April 24, 2025

Re: Snopac Property Uplands Draft Cleanup Action Plan and In-water Feasibility Study

**Figure 8.**  
 Conceptual Design for Shoreface Remedy  
 Sediment Feasibility Study  
 Snopac Property

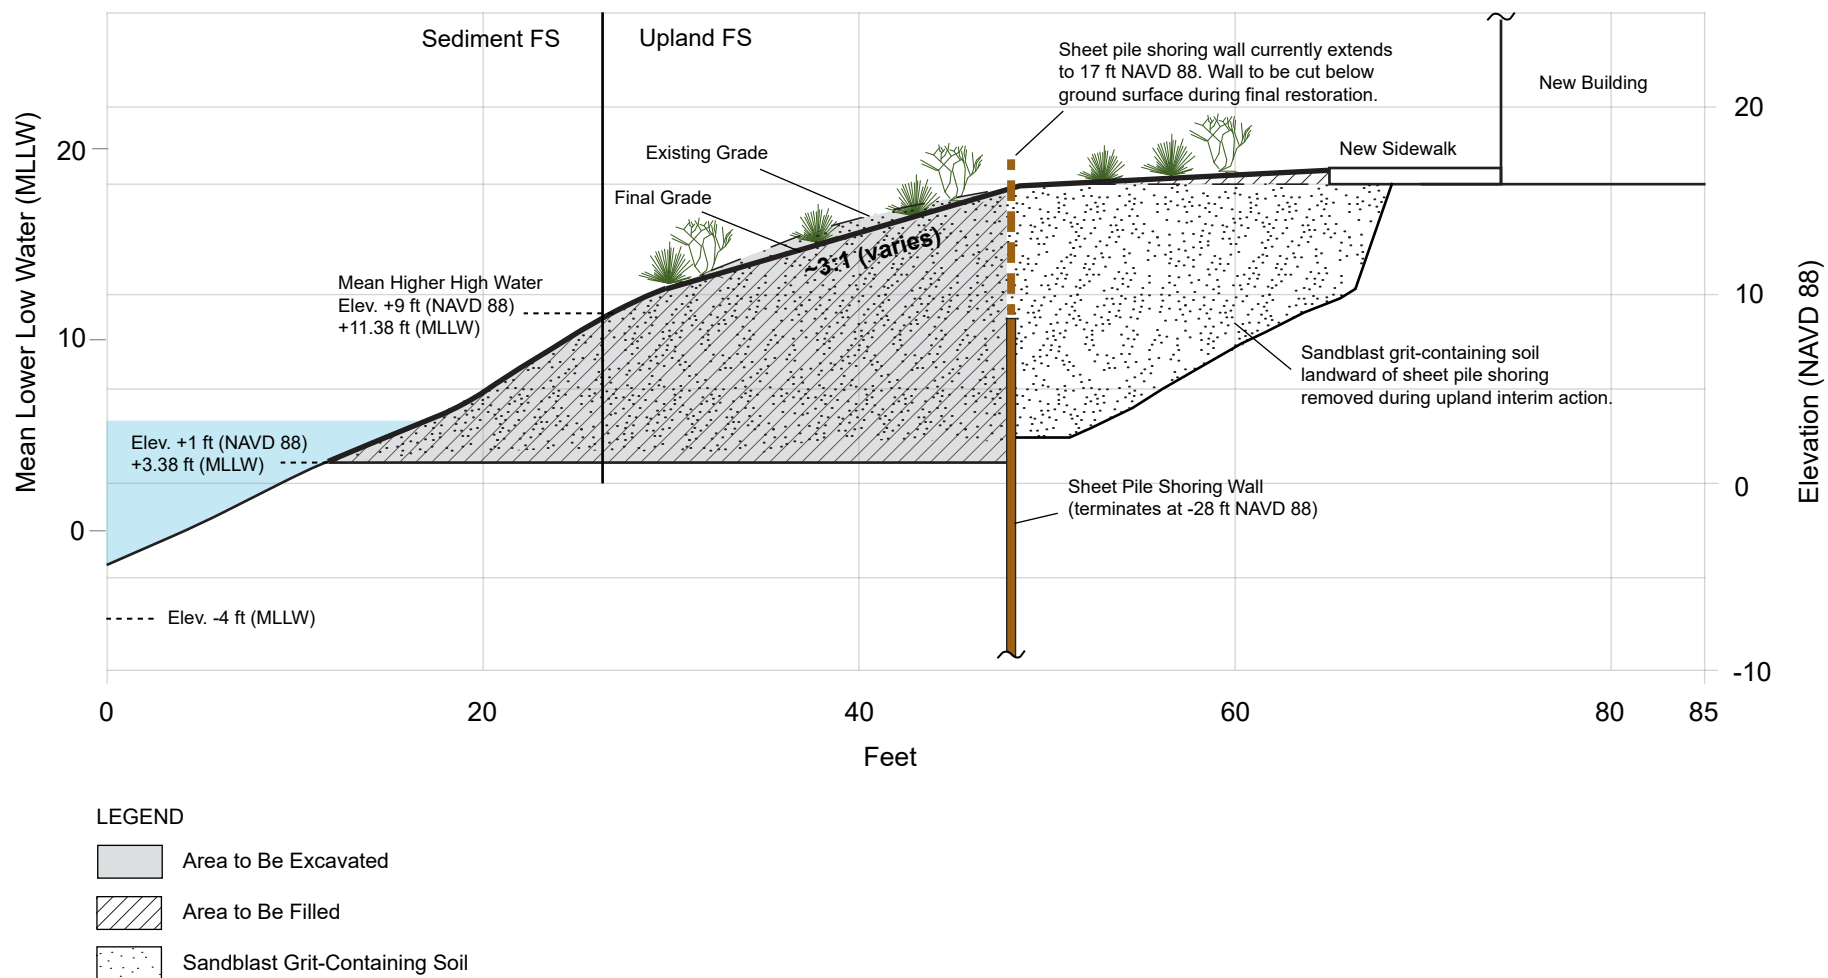
The Draft Uplands Cleanup Action Plan notes that stable slopes will be re-established by adding the smallest sized substrate that would remain stable on the slopes, but that large rock may be needed to provide stability. This will include a shallow slope up to the existing retaining wall. The retaining wall is approximately 7 ft high, 270 ft long, and extends the full length of the shoreface on the western property boundary. The Sediment Feasibility Study notes that a shoring wall was installed in 2020 to stabilize the existing “makeshift retaining wall”. Additionally, the Snopac site has been cleared and the building removed, leaving space for additional habitat.

Ecology should consider the public trust and interest and the needs of the State’s wildlife in the cleanup of the site. Because the existing retaining wall appears to be unstable, Ecology should request removal and replacement of dilapidated infrastructure to support a shallow slope from the river to the shoreline, which should include riparian vegetation. This would help reduce runoff from the existing upland property which consists of

If a retaining wall is maintained, we request a long-term bond (100 yrs) for protection and maintenance of any constructed wall to ensure that it remains protective for the long term and is maintained through unanticipated changes to sea level rise and other river dynamics resulting from climate change.

Currently, there are two existing retaining walls along the shoreline of the site: one “makeshift retaining wall” and a permitted engineered sheet pile shoring wall installed in 2020. As outlined in the Sediment FS, the existing “makeshift retaining wall” structure will be removed along with other debris, including metal, concrete, wood, and sediment. The sheet pile shoring wall installed in August 2020 will remain but will be cut below grade. The shoreface slope will be reestablished based on the physical constraints of the site ([see Figure 8 of Sediment FS](#)<sup>5</sup>).

The surface of the new and re-sloped shoreface would likely need rock to prevent erosion, but a sandy gravel habitat mix would be applied over and between the larger rocks to improve the ecological function. This will provide greater habitat function than what currently exists.

Following slope adjustment, all areas landward of the ordinary high water mark, within the project area along the shoreline, would be planted with native trees, shrubs, and plants to increase riparian habitat in this area. The plantings would be designed to integrate with human upland uses where an office building is expected while creating an aesthetically pleasing, yet functioning, native riparian habitat.
